The R&A  
St Andrews, Fife  
Scotland KY16 9JD

8 May 2015

To: **ALL MANUFACTURERS**

## **SPRING EFFECT AND DYNAMIC PROPERTIES**

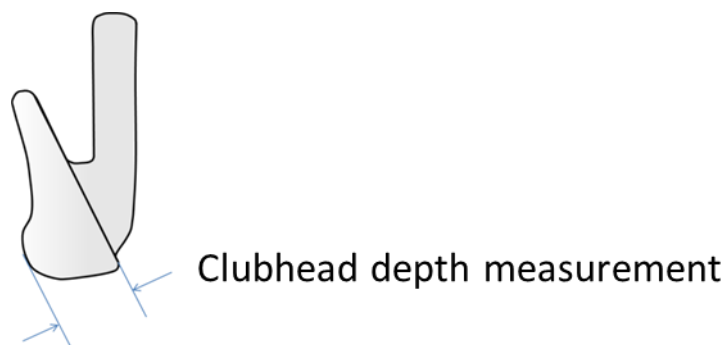
1. All clubs (except putters) with claimed, marked or measured lofts of 35 degrees or less, and a clubhead depth exceeding 1.5 inches (see figure below illustrating the measurement method) or a radius of curvature of the face that is less than or equal to 30 inches will be evaluated for spring effect solely using the Pendulum Test. The maximum characteristic time (CT) over the entire impact area<sup>1</sup>, will be 239 microseconds (plus an 18 microsecond tolerance). It is proposed that the

maximum characteristic time outside the impact area be 257 microseconds (plus an 18 microsecond tolerance). All tests will be performed using the modified Pendulum device, which de-lofts the club face.
